Office Action Summary

10/718,021

TAYLOR, BRIAN J.

DETAILED ACTION

Applicant's Diagram 1 showing Knox's arrangement, used to illustrate "upstream" and "downstream" limitations

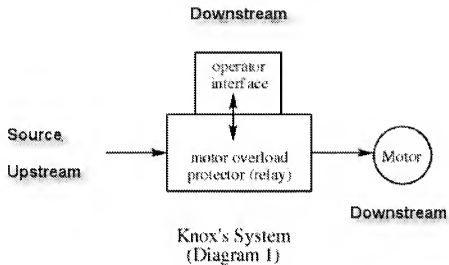
components are mounted to Housing Base 41 and are modularized/replaceable], wherein the modular control unit is coupled electrically downstream of the motor protection device [see Diagram 1 below for illustration. The Modular Control Unit 2, labeled "Operator Interface" is *downstream* of the source since 2 receives power from the source. Note that power is supplied to the entire Digital Programmable Overload Protector 1 (including Modular Control Unit 2) via power input 12, Fig. 1, pars. 0102, 0105] and comprises control circuitry [Modular Control Unit 2 contains Microcontroller 75] configured to be coupled electrically upstream of a motor [see Diagram 1 below for illustration. The Modular Control Unit 2, labeled "Operator Interface" is *upstream* with respect to the Motor because 2 is electrically coupled between the source and the motor, inside of Digital Programmable Overload Protector 1 in order to receive power and data via connector block 23 (Figs. 2 and 4; par. 0088) and connector pad 80 (Fig. 5, par. 0105)] of the machine and control the motor in operation [the circuitry of microcomputer 75 allows the user to enter control commands and receive status updates of the motor being controlled- par. 0104-0109. The machine being controlled is the low voltage motor mentioned in paragraph 0002].

Applicant argues that "the applicant's control circuitry is recited as being disposed between the protection device and the motor, and controls the motor." The examiner disagrees, and notes that the limitation of claim 1 specifically requires "the modular control unit is coupled electrically downstream of the motor protection device" and "comprises control circuitry configured to be coupled electrically upstream of a motor of the machine and control the motor in operation. Knox is seen to disclose the recited limitations, as explained in the rejection of claim 1 above.

Applicant argues on page 16 that "Knox is completely silent with regard to control circuitry being electrically downstream of a protection device." The examiner disagrees. As understood, the terms upstream and downstream serve to identify the location of the

source (presumably upstream) and the location of any load devices (presumably downstream). Knox discloses wherein the modular control unit is coupled electrically *downstream* of the motor protection device [see Diagram 1 above for illustration. The Modular Control Unit 2, labeled "Operator Interface" is *downstream* of the source since 2 receives power from the source. Power is supplied to the entire Digital Programmable Overload Protector 1 (including Modular Control Unit 2) via power input 12, Fig. 1, pars. 0102, 0105].

Applicant's Diagram 3 showing Brown's arrangement, used to illustrate "upstream" and "downstream" limitations

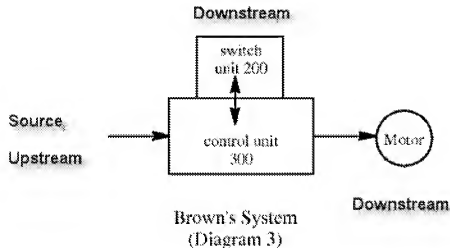
a modular motor control unit [Fig. 1, Switch Unit 200] coupled to the modular base [col. 2 lines 24-45; col. 3 lines 16-18] electrically downstream of the motor protection circuitry [Switch Unit 200 is downstream of the protection circuitry on Circuit Board 306, 308 inside of Control Unit 300 (see Figs. 2 and 5) because circuit boards 306, 308 are closer to the source than Switch Unit 200. Note in Fig. 1 that power is first received by control unit 300 (which contains Circuit Boards 306, 308) via the terminal blocks indicated at 300, then power is sent to Switch Unit 200 via the terminals indicated at 302. See Diagram 2 below for illustration] and comprising motor control circuitry [comprising switch 202 of Switch Unit 200 and circuit board 206. Col. 3 lines 36-42] configured to be coupled electrically upstream of the motor [Switch 202 and circuit board 206 of Switch Unit 200 is electrically coupled to control unit 300, which is *upstream* of the motor in order to control/protect the motor, thus 202 and 206 are upstream of the motor. See Diagram 3 below], wherein the motor control circuitry is cooperatively operable with the motor protection circuitry, the modular motor control unit being selectively replaceable from a plurality of different types of motor control units [col. 7 lines 55-62; col. 8 lines 8-12; col. 8 lines 21-31], and

2 and 5) because circuit boards 306, 308 are closer to the source than Switch Unit 200. Note in Fig. 1 that power is first received by control unit 300 (which contains Circuit Boards 306, 308) via the terminal blocks indicated at 300, then power is sent to Switch Unit 200 via the terminals indicated at 302. See Diagram 2 below for illustration] and comprising control circuitry [col. 9 lines 3-14; col. 9 lines 66-67 and col. 10 lines 1-11] configured to be coupled electrically upstream of the motor [Switch 202 and circuit board 206 of Switch Unit 200 is electrically coupled to control unit 300, which is *upstream* of the motor in order to control/protect the motor, thus 202 and 206 are upstream of the motor. See Diagram 3 above] at least one machine in the machine system and control the motor in operation [an ON/OFF command constitutes control], wherein the control unit is selectable from a plurality of different types of control units having different types of control circuitry [col. 7 lines 55-62; col. 8 lines 8-12; col. 8 lines 21-31], the control unit is replaceably mountable to the on-machine base [as seen in Fig. 1], and the on-machine base and the control unit are cooperative to provide desired on-machine controllability.

the modular switch unit 200 is a modular motor control unit (with which the applicant does not agree), the applicant stresses that the modular switch unit 200 is not electrically downstream of a motor protection device/circuitry, and *does not control the motor in operation.*" The examiner disagrees. Switch Unit 200 is a modular control unit because Brown discloses it as such. Col. 3 lines 16-18 state "...Switch Unit 200 and a control unit 300 which can be selectively coupled together in a modular manner." Thus Switch Unit 200 is modular. Col. 3 lines 25-28 state "...the switch 200 is operably coupled to the controller 302 whereby the controller 302 may appropriately control the power source when the switch is converted to the emergency state." Thus Switch Unit 200 controls the ON/OFF state of a motor. Further, Switch Unit 200 is seen to be *downstream* of the protection circuitry on Circuit Board 308 inside of Control Unit 300 (see Figs. 2 and 5) because circuit board 308 is closer to the source than Switch Unit 200. Note in Fig. 1 that power is received by control unit 300 (which contains Circuit Board 308) via the terminal blocks shown, then power is sent to Switch Unit 200 via the terminals shown at 302. See Diagram 2 above for illustration.
